## Packet Guide

**1. Certificate of Appropriateness Application**

BAR 20-09-01

Renaissance School--replace five windows

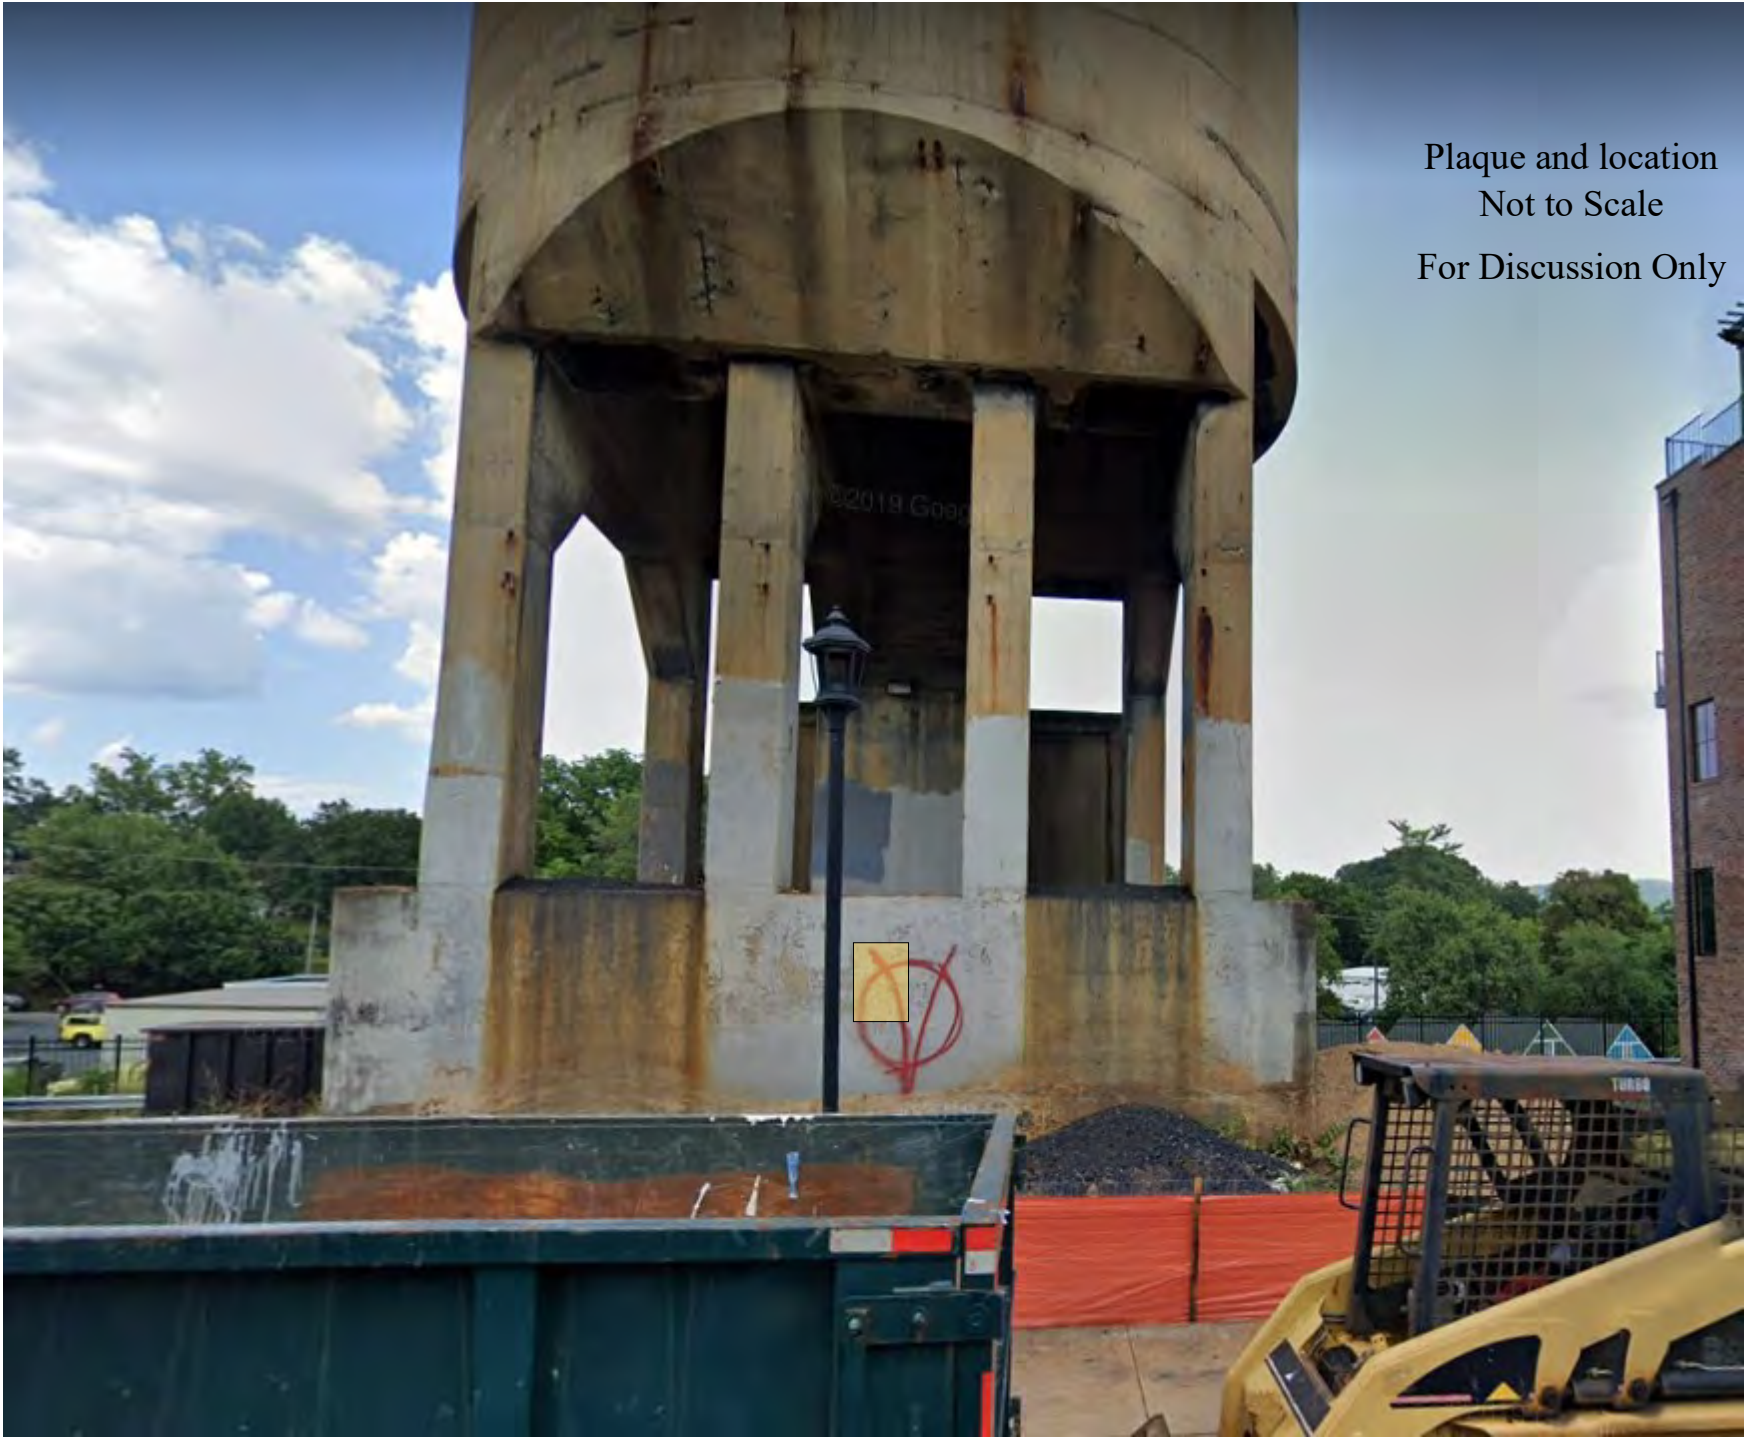
Staff has not evaluated the proposed text; however, the cited work is by Thomas W. Dixon, Jr., a well-known author and historian of railroad history. Staff recommends only that the text be modified to be consistent with the contemporary style guides. Specifically:

- *C&O* should have spaces, C & O.
- 8 should be spelled out, eight.
- In the second paragraph, delete the second reference to the tower's 300-ton capacity.
- In the second paragraph, delete the word *today*.
- In the last sentence, delete the second comma.

REVISED FRONT PORTICO DETAILS

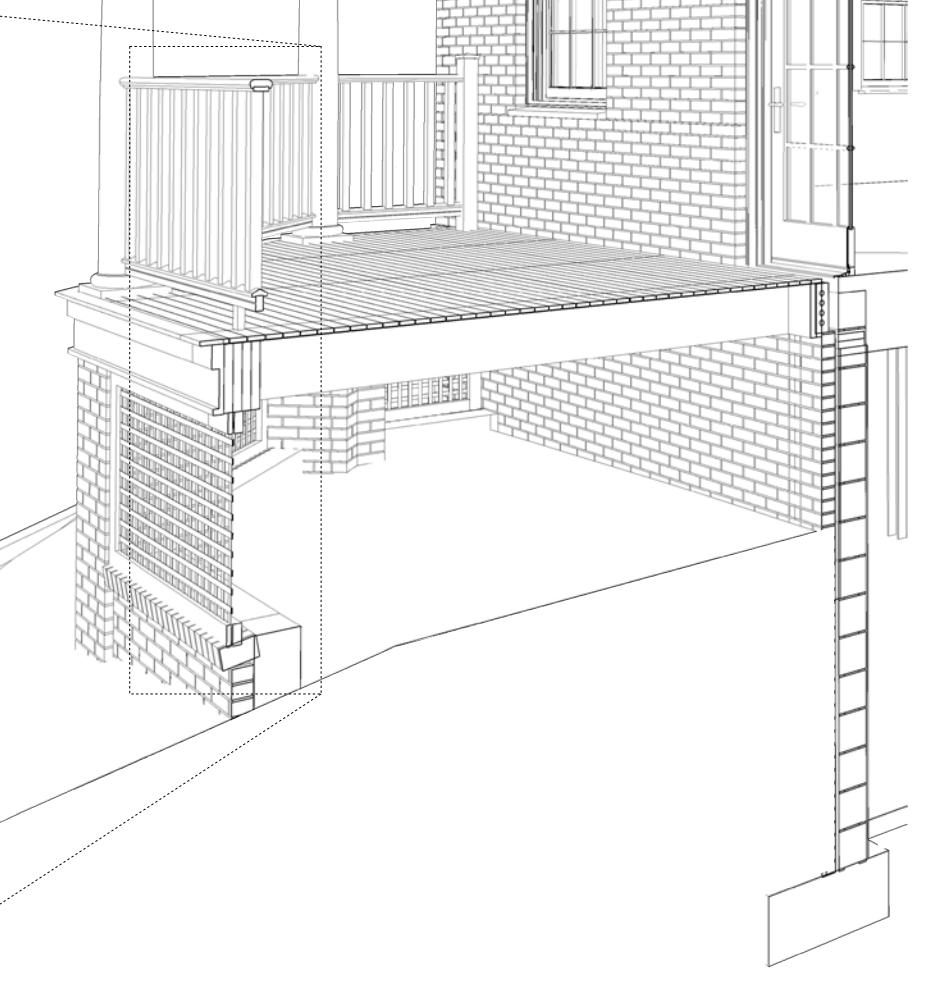
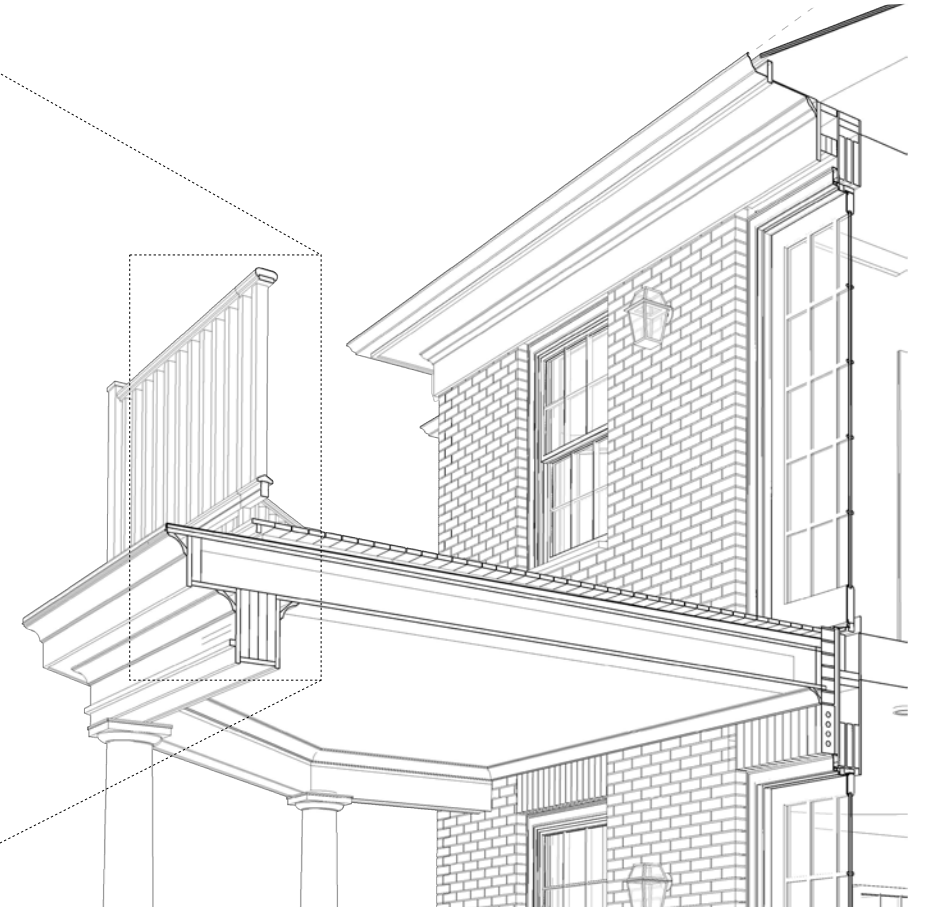
PORTICO TRIMS TO BETTER AGREE WITH MADISON LANE PRECEDENTS

BLACK RAIL TO "DISAPPEAR"

REVISED SIDE PORCH DETAILS

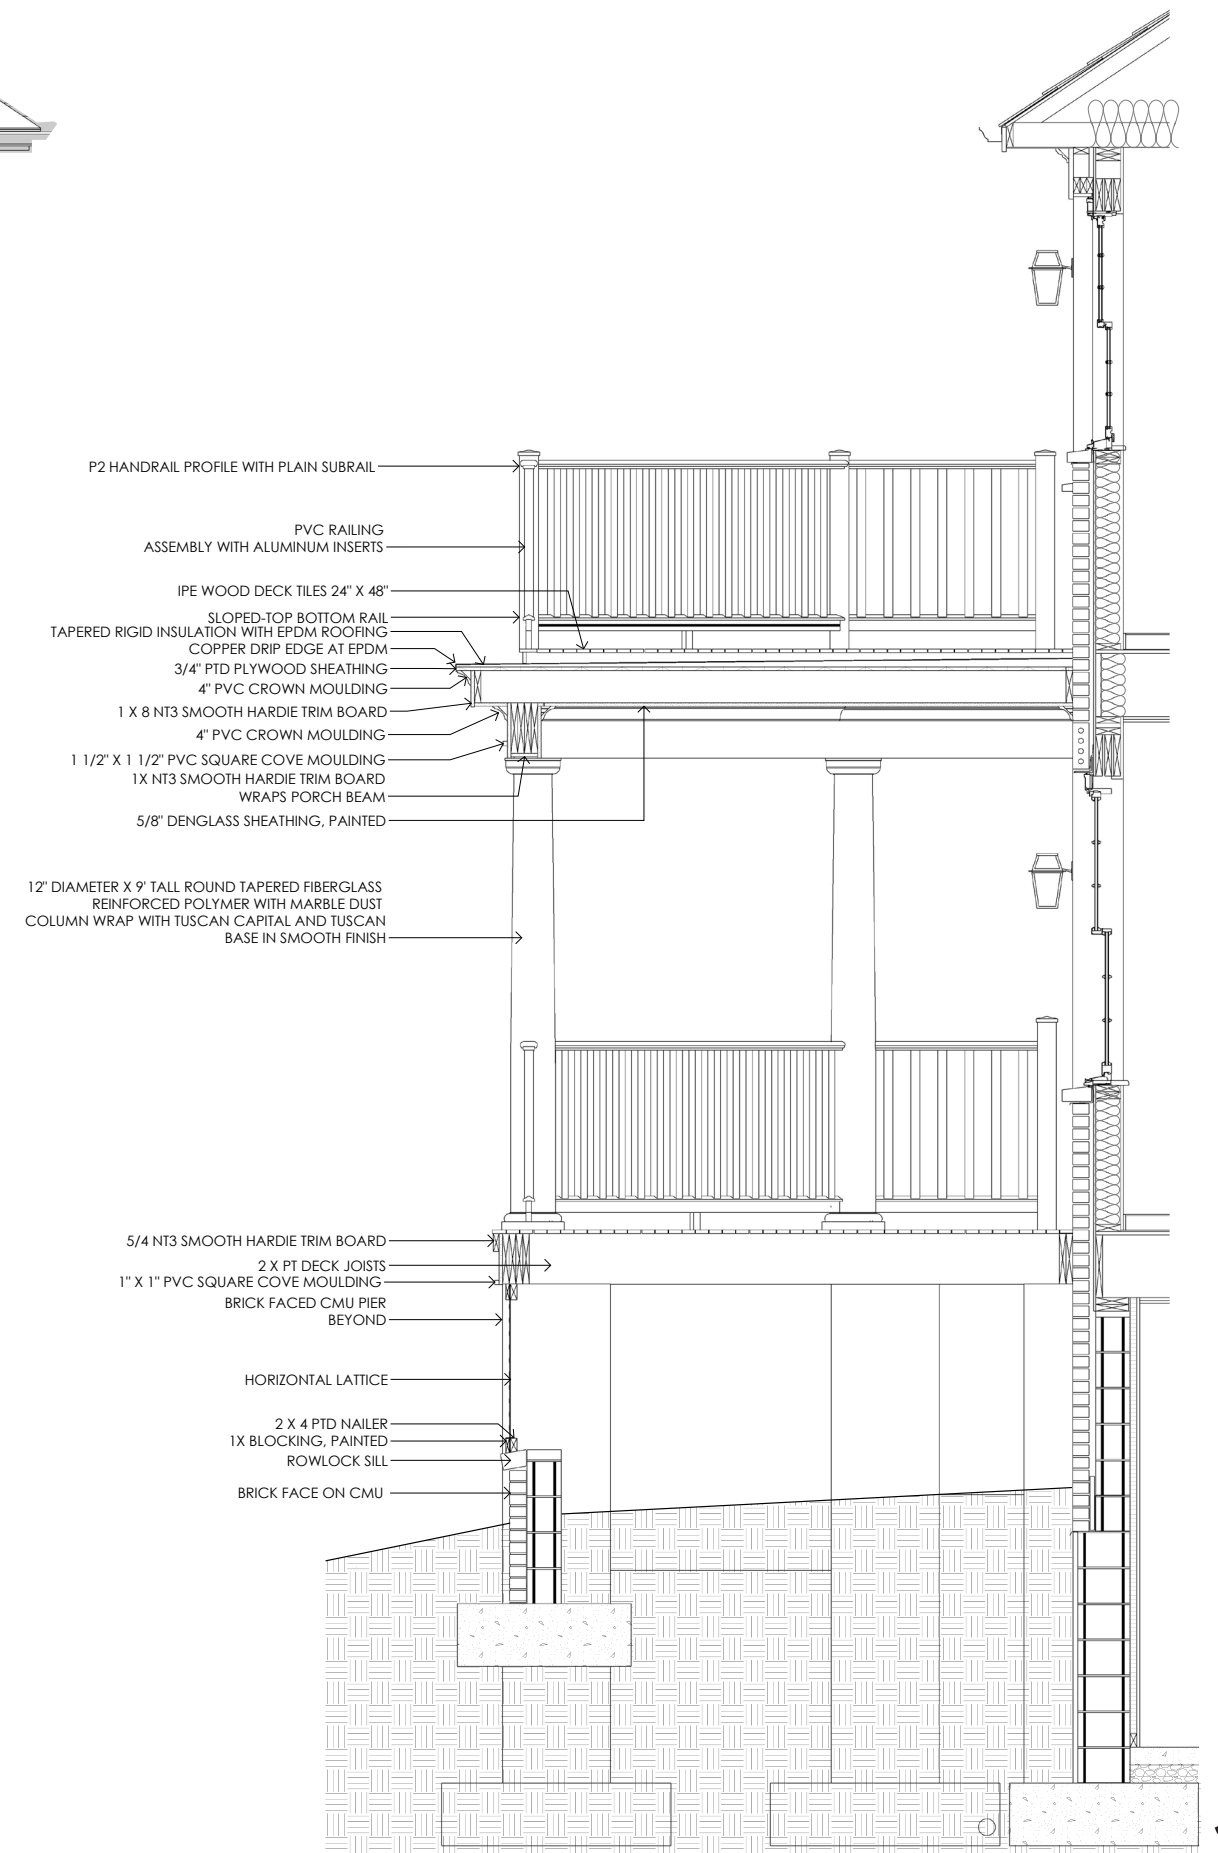
RAILING SET BACK TO ACT AS A SECONDARY ELEMENT

HEAVY ELEMENT TO READ AS ROOF

SINGLE STORY COLUMNS SCALED TO HEIGHT

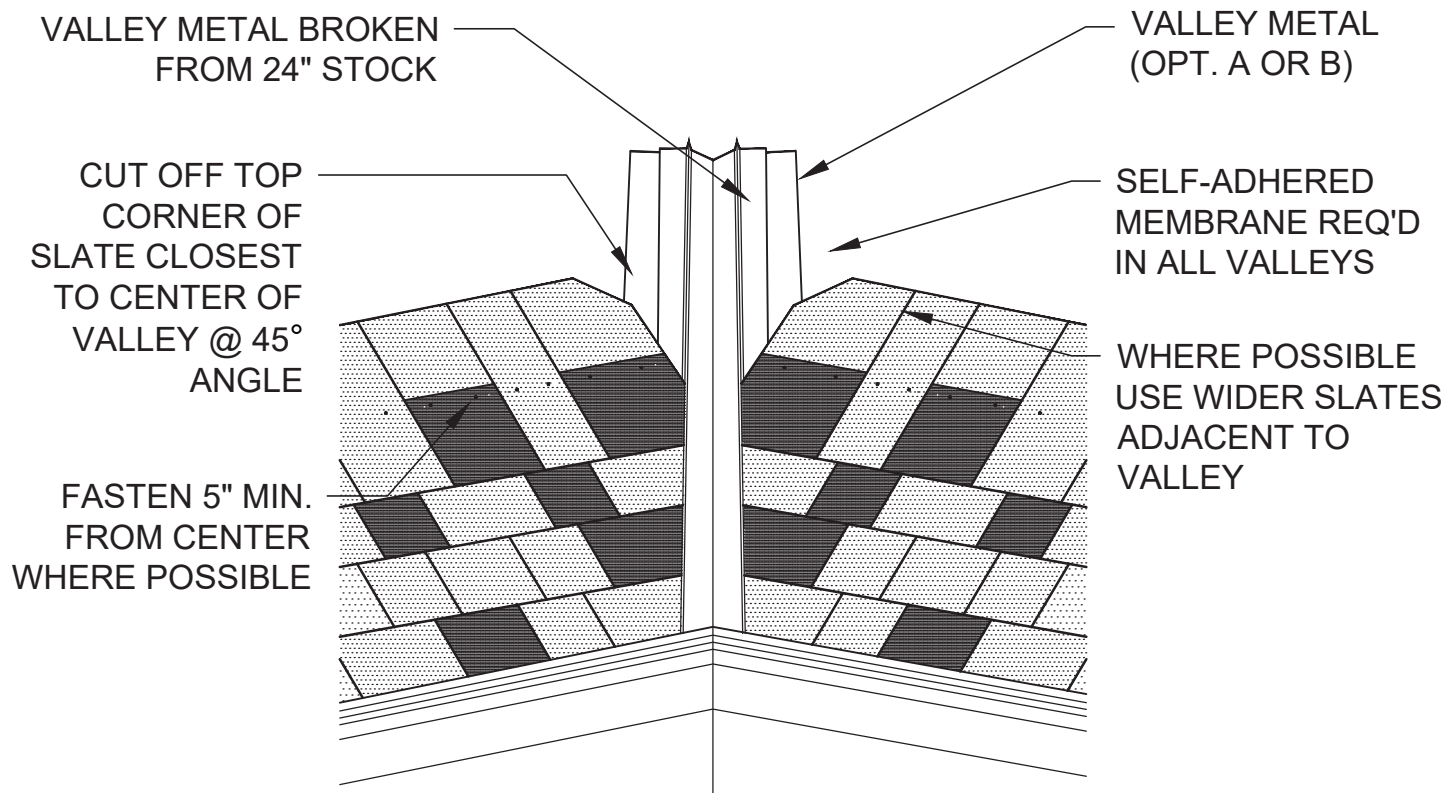
Staff recommends BAR discuss and clarify the roof flashing details. Otherwise, staff recommends approval of the CoA.
